**BID No. 23-24-01 Construction Services for SJC Industrial Park Improvements  
Project**

**ADDENDUM #2  
August 15, 2023**

**Addendum #2 Response to Bidders**

Project Name San Juan County Industrial Park

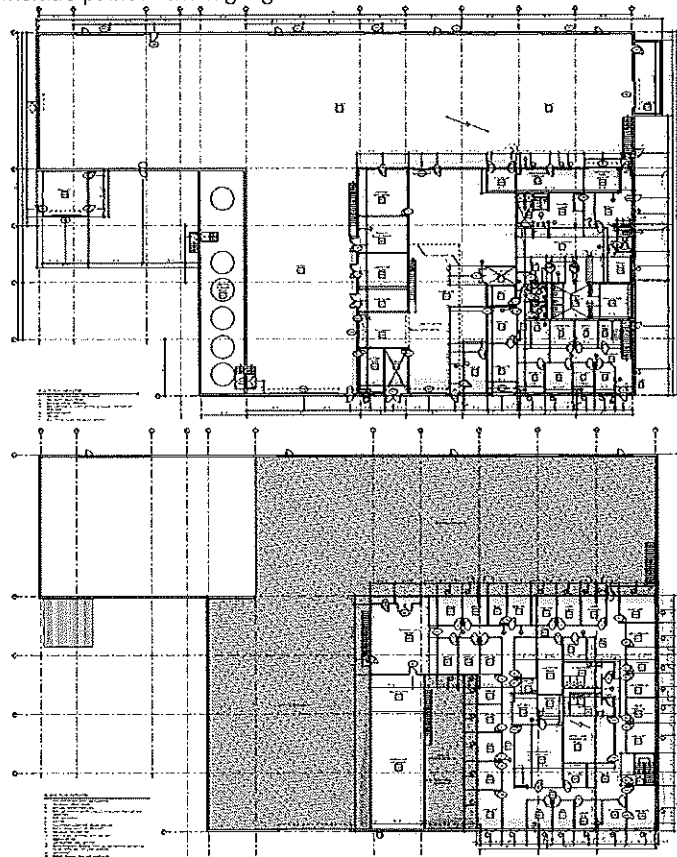
Question 6 From the walk through it seems as if there should be some additional paint scope that is not shown on the plans. Can you please provide a square footage value and if we are matching existing or what the intent is? If we are matching existing there might be the issue with the age of the existing paint and the color variance after time.

Answer 6 Include paint in the highlighted areas
